Issues with ONU re-registration in 802.3ca

Glen Kramer, Broadcom

Figure 144-22—ONU Registration state diagram

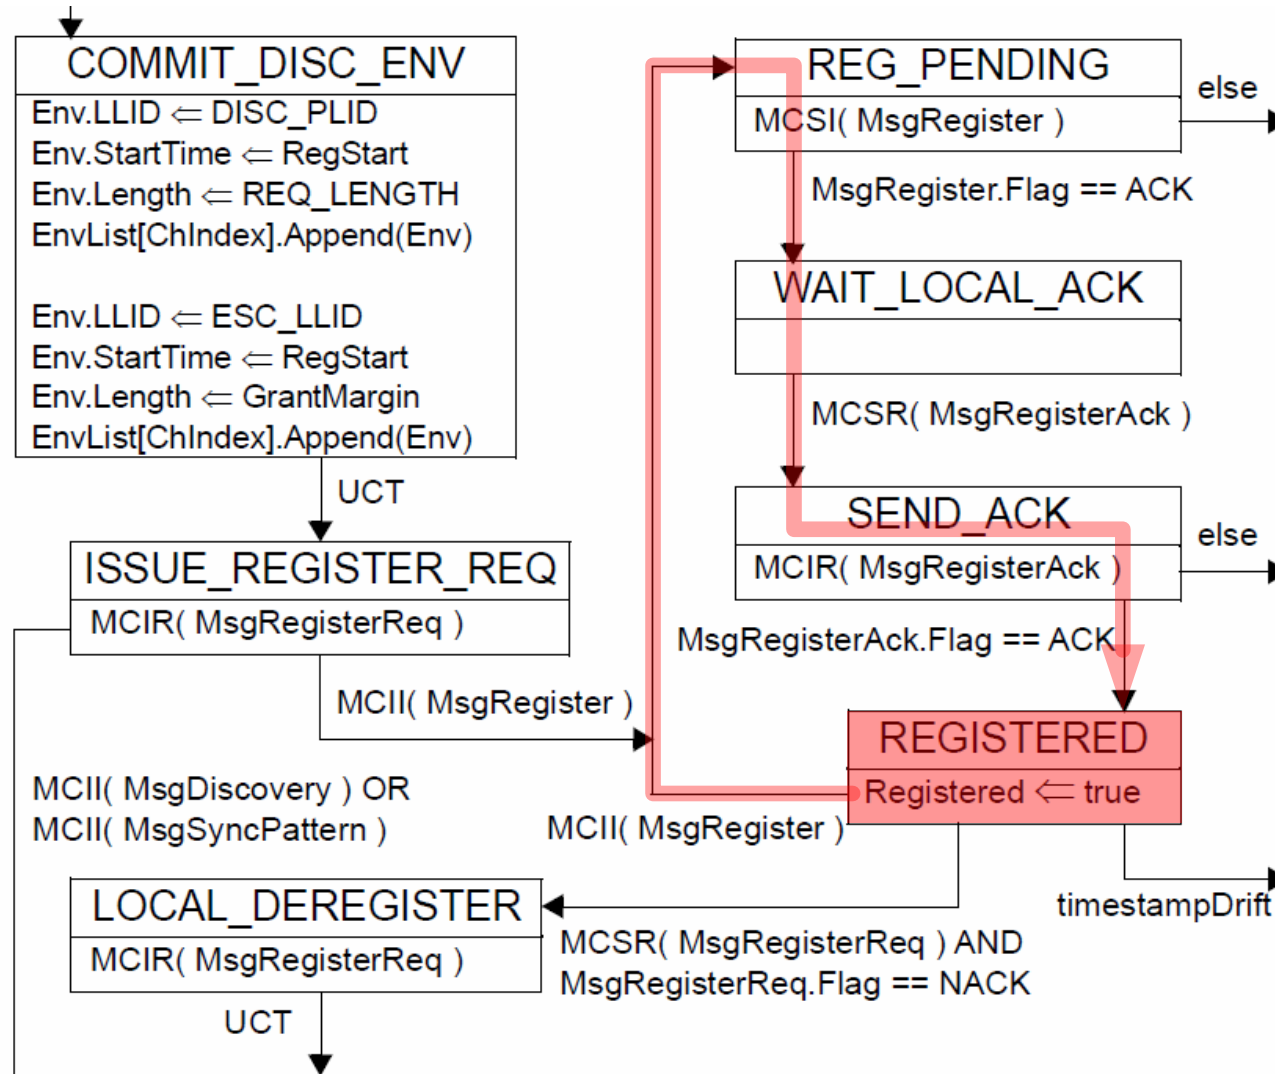
- ❑ ONU Registration state diagram 144-22 supports re-registration, but the OLT Registration state diagram 144-21 can never send a REGISTER MPCPDU for re-registration. This is an error in the state diagram.

1. A registered ONU receives REGISTER MPCPDU on its assigned PLID
2. ONU transitions to state REG_PENDING. *Registered* variable remains 'true'. Payload of REGISTER MPCPDU is passed to MPCP Client.
3. If REGISTER Flag was ACK (i.e., this is a re-registration), go to state WAIT_LOCAL_ACK and wait for the MPCP client to confirm setting new parameters.
4. When new parameters are confirmed, generate REGISTER_ACK MPCPDU and queue it for transmission (may be on a new PLID).
5. Return to REGISTERED state.

Figure 144–21—OLT Registration Completion state diagram

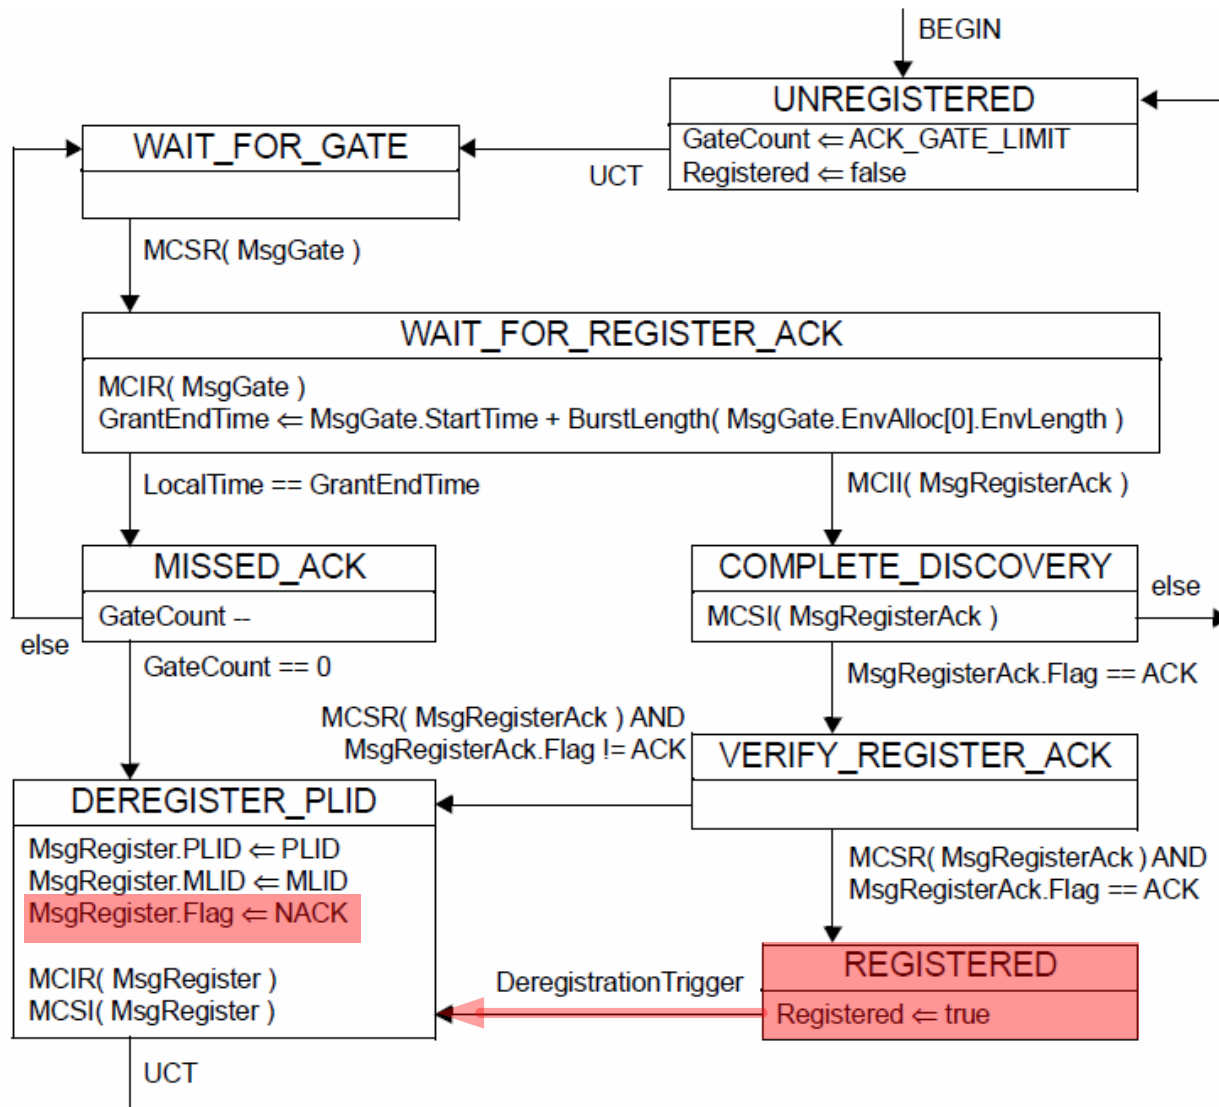
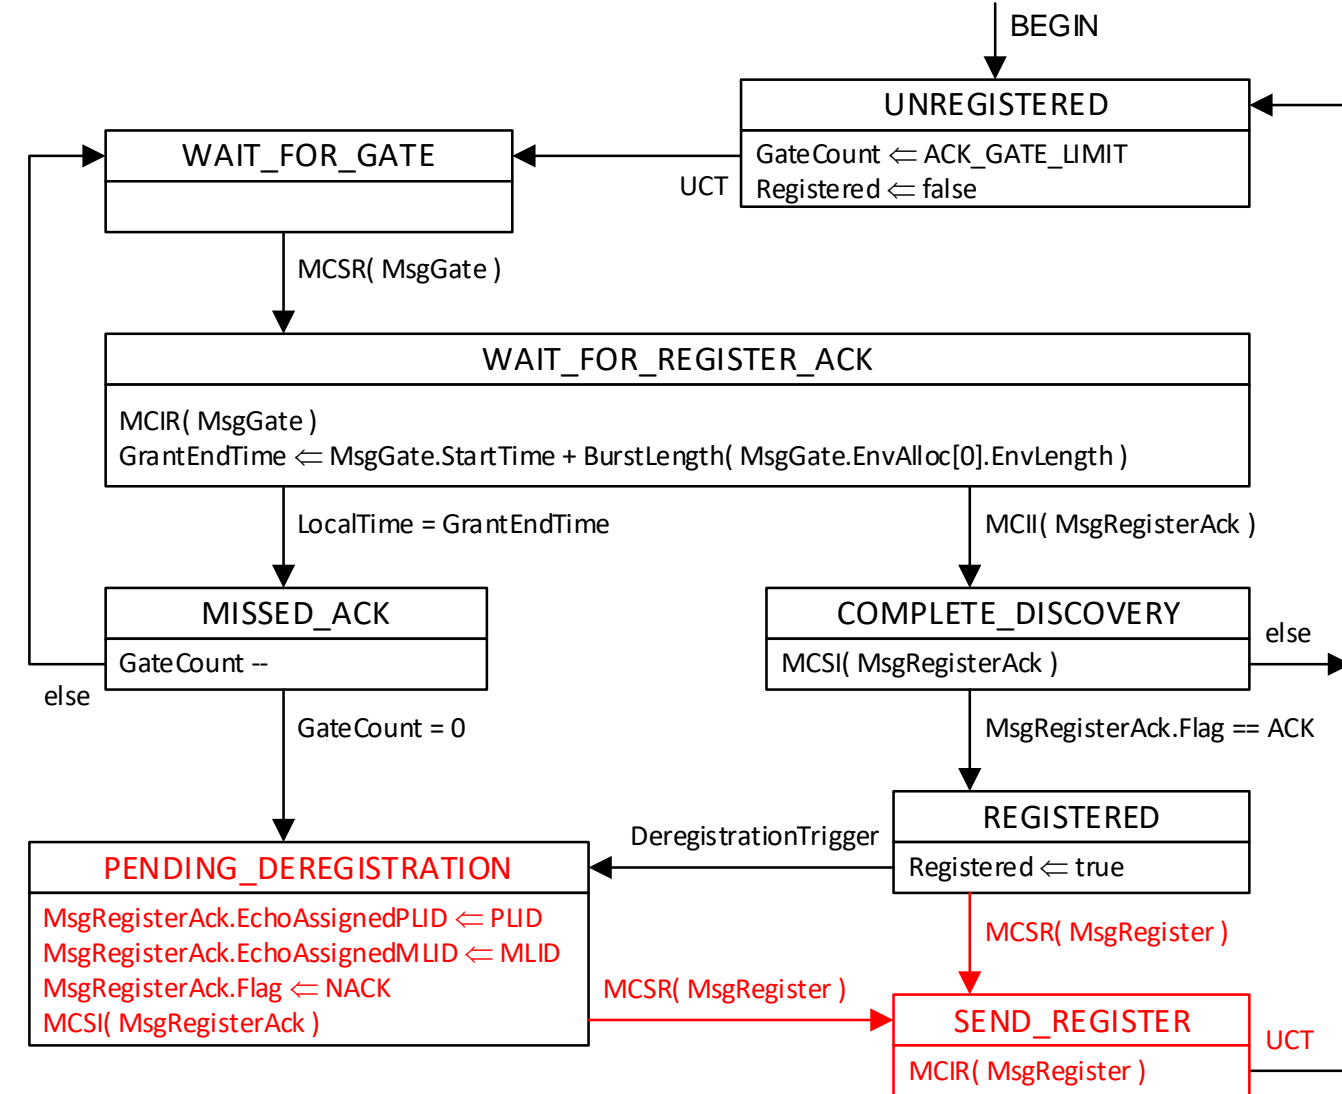
1. *DeregistrationTrigger* only activates when OLT wants to deregister the ONU
2. OLT always sends REGISTER MPCPDU with Flag = NACK (in state DEREGISTER_PLID). In no state can the OLT send REGISTER with Flag = ACK.
3. Another issue: Deregistration REGISTER MPCPDU does not carry *Sp1Length*, *SP2Length*, *SP3Length* and *EchoPendingEnvelopes* values, in violation of 144.3.6.4.

- ❑ Modify OLT Registration Process state diagram (Fig 144-21) as shown.
- ❑ In PENDING_DEREGISTRATION state, the OLT Registration Process informs the MPCP Client about the events that client cannot detect:
 1. REGISTER_ACK form ONU is not received after ACK_GATE_LIMIT attempts
 2. *DeregistrationTrigger* is activated (see next slide)

(Message MsgRegisterAck is formed in the PENDING_DEREGISTRATION state and is passed to local MPCP Client as an indication, i.e., it is reused for local intra-layer signaling).
- ❑ The decision to de-register or re-register always comes from the MPCP client.
